Stage 5 Clarification Questions for ACP 2018-65

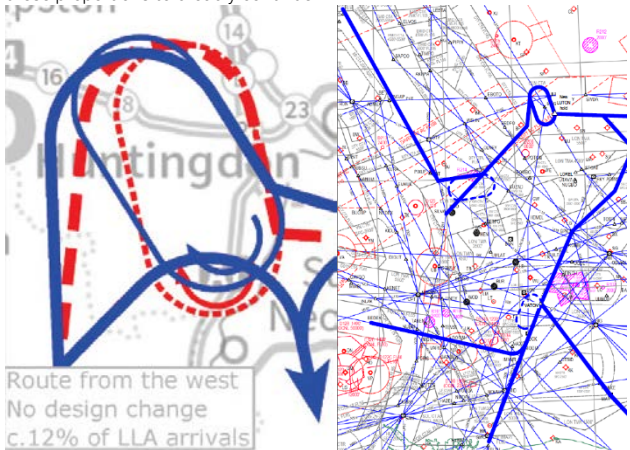
8	<p>Consultation Response Document, 20/6.29.8</p>	<p>What does, 'they could not be kept higher than as consulted upon' mean?</p>	<p>Gen</p>	<p>18/08/2021</p>	<p>Para 6.29 and Fig14 describe the opportunity to keep aircraft higher. This opportunity can only apply to the east-to-west arrival flow in Fig14, which does not include the arrival flows from the south, west and northwest because those arrival flows are altitude-constrained by other flows. This is the intent of that text in para 6.29.8; "they could not be kept higher than as consulted upon" means that the other consulted-upon flows could not be raised due to these constraints. A change to the document is not considered necessary, as para 6.29.9 explains that the east-to-west flow is the only flow where this opportunity exists.</p>
9	<p>Consultation Response Document, 22/6.40</p>	<p>What is a 'main arrival route'? How often will this route be used?</p>	<p>Tech/ATM</p>	<p>18/08/2021</p>	<p>The context of this sentence is linked to the previous query above. The sentence's wider context, "adjusting one of the main arrival routes", singles out one of the generic arrival flows illustrated in all the various consultation materials and feedback documents, arriving at the proposed new hold.</p> <p>Its intent was to explain, as per the previous query, that only one of the consulted-upon arrival flows could be raised.</p> <p>To answer the second part of the query, para 8.8.1 and 8.8.2 and Fig17 (p.30-31) describe that the combined arrivals from the east would expect to be used by c.52% of all LLA arrivals. A change to the document is not considered necessary.</p>
